19/0050 - 13-23 GIBBONS STREET, REDFERN - property development - SSD 9194 Attention: Ellen Mannix

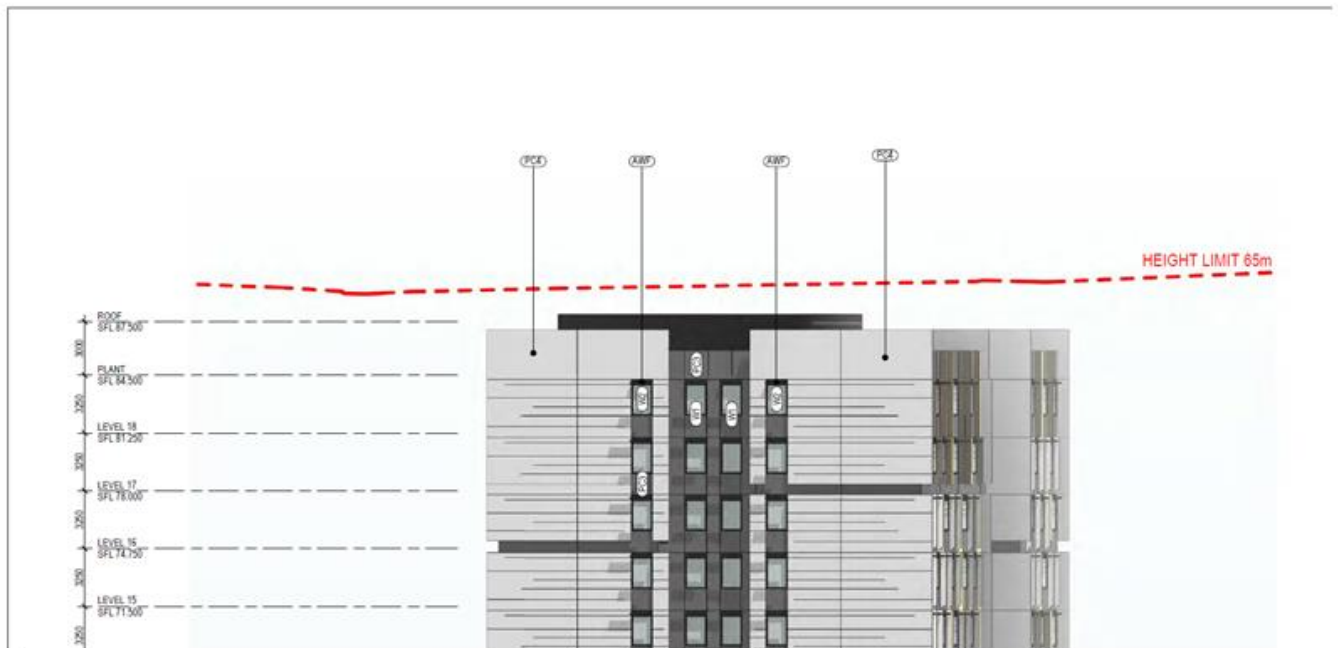
The attached screen shot shows one of the drawings provided.

I believe the overall height of the building is more than 87.5m AHD as shown.

Please provide an elevation drawing showing the overall maximum height of the building.
